END R.O.W. PROJECT  
BRF 025-1 (24) STA. 41+00 ±

SHREWSBURY  
BRF 025 1(24)  
R.O.W. SHEET 6 OF 9

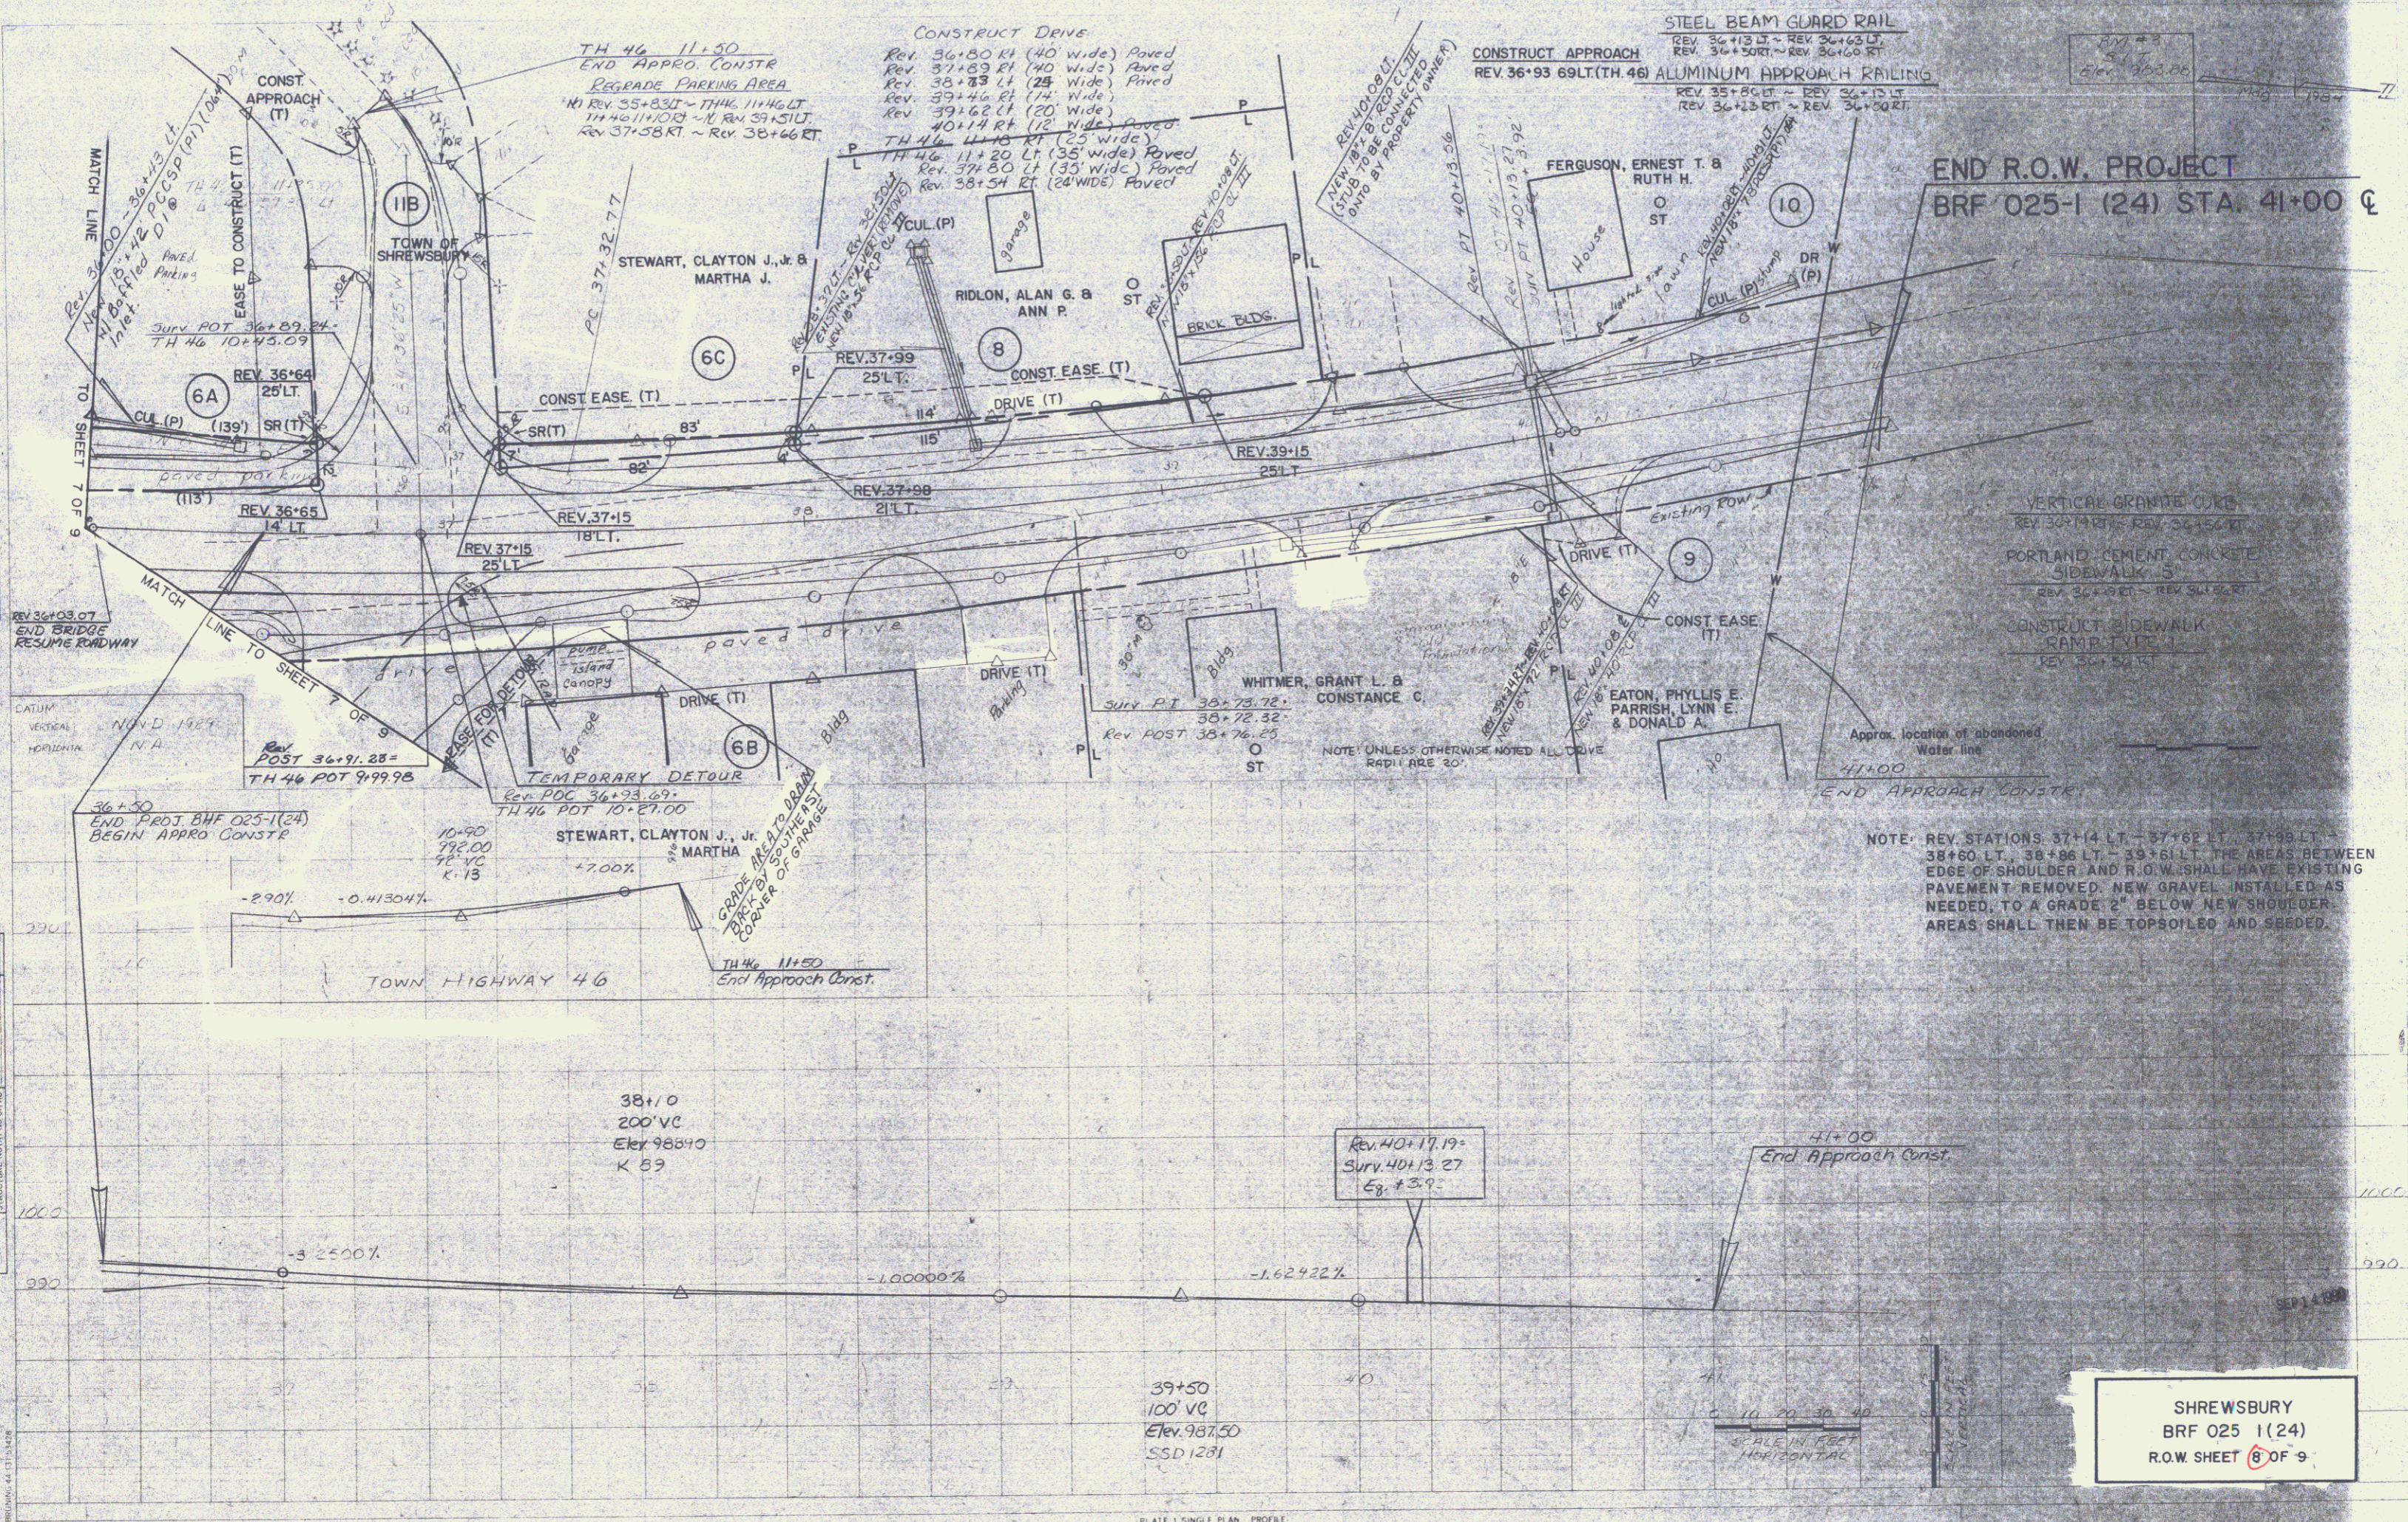
- VERTICAL GRANITE CURB  
REV. 36+14 RT - REV. 36+15 RT
- PORTLAND CEMENT CONCRETE  
SIDEWALK 5"  
REV. 36+00 RT - REV. 36+00 RT
- CONSTRUCT SIDEWALK  
RAMP 1/2" x 4"  
REV. 36+15 RT

NOTE: REV. STATIONS: 37+14 LT - 37+62 LT, 37+99 LT - 38+50 LT, 38+86 LT - 39+61 LT. THE AREAS BETWEEN EDGE OF SHOULDER AND R.O.W. SHALL HAVE EXISTING PAVEMENT REMOVED. NEW GRAVEL INSTALLED AS NEEDED TO A GRADE 2" BELOW NEW SHOULDER. AREAS SHALL THEN BE TOPSOILED AND SEED.
